Access Compliance Report

Public Rights-of-Way

(Pedestrian Signals)

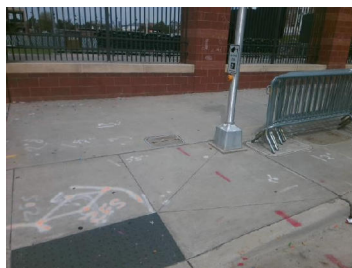
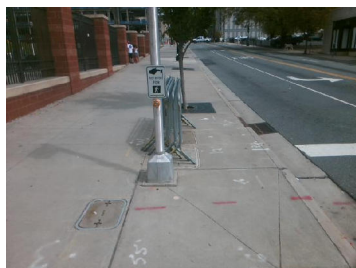
Compliance	Description	Data	Compliance	Description	Data
	Button Count	Button1	N/A	Distant to Additional Button (in)	N/A
	Additional Button Present?	No		Additional Button ID	N/A
N/A	Signal Buttons Required?	N/A	N/A	Additional Ped Posts Required	N/A
	How Many Ped Street Xings?	1		Located In An Island/Median?	No
N/A	B 1 Sign Present?	Yes	N/A	B 2 Sign Present?	N/A
Yes	B 1 Sign Purpose?	Yes	N/A	B 2 Sign Purpose?	N/A
Yes	B 1 Sign Lettering & Contrast?	Yes	N/A	B 2 Sign Lettering & Contrast?	N/A
Yes	B 1 Parallel To XWalk?	Yes	N/A	B 2 Parallel To XWalk?	N/A
Yes	B 1 PAR to Button?	Yes	N/A	B 2 PAR to Button?	N/A
Yes	B 1 PAR to XWalk?	Yes	N/A	B 2 PAR to XWalk?	N/A
Yes	B 1 Clear Floor Space?	Yes	N/A	B 2 Clear Floor Space?	N/A
N/A	B 1 FWD Approach?	Yes	N/A	B 2 FWD Approach?	N/A
N/A	B 1 FWD Approach Constrained?	No	N/A	B 2 FWD Approach Constrained?	N/A
No	B 1 FWD Approach Reach (in)	3.0	N/A	B 2 FWD Approach Reach (in)	N/A

N/A	B 1 FWD Approach Width (in)	N/A	N/A	B 2 FWD Approach Width (in)	N/A
N/A	B 1 FWD Approach Obstruction?	Yes	N/A	B 2 FWD Approach Obstruction?	N/A
N/A	B 1 FWD Approach Obstruction Dist (in)	3.0	N/A	B 2 FWD Approach ObstructionDist (in)	N/A
N/A	B 1 PARA Approach?	Yes	N/A	B 2 PARA Approach?	N/A
N/A	B 1 PARA Approach Constrained?	No	N/A	B 2 PARA Approach Constrained?	N/A
Yes	B 1 PARA Approach Reach (in)	3.0	N/A	B 2 PARA Approach Reach (in)	N/A
N/A	B 1 PARA Approach Width (in)	N/A	N/A	B 2 PARA Approach Width (in)	N/A
N/A	B 1 PARA Approach Obstruction?	Yes	N/A	B 2 PARA Approach Obstruction?	N/A
N/A	B 1 PARA Approach Obstruction Dist (in)	3.0	N/A	B 2 PARA Approach ObstructionDist (in)	N/A
Yes	B 1 Clear Floor Space Slope (%)	2.7	N/A	B 2 Clear Floor Space Slope (%)	N/A
Yes	B 1 Clear Floor Space XSlope (%)	1.7	N/A	B 2 Clear Floor Space XSlope (%)	N/A
N/A	B 1 PAR Slope (%)	3.2	N/A	B 2 PAR Slope (%)	N/A
Yes	B 1 Height (in)	41.0	N/A	B 2 Height (in)	N/A

Yes	B 1 Clear Xing Direction?	ClearlyMarked	N/A	B 2 Clear Xing Direction?	N/A
	B 1 Crossing Direction	To SE		B 2 Crossing Direction	N/A
Yes	B 1 DistanceTo XWalk (in)	28.0	N/A	B 2 DistanceTo XWalk (in)	N/A
No	B 1 DistanceTo Curb (in)	73.0	N/A	B 2 DistanceTo Curb (in)	N/A
Yes	B 1 Diameter (in)	2.0	N/A	B 2 Diameter (in)	N/A

Possible Solutions: Replace Signal Push Button With APS Button on New Post. Remove & Relocate Sign.
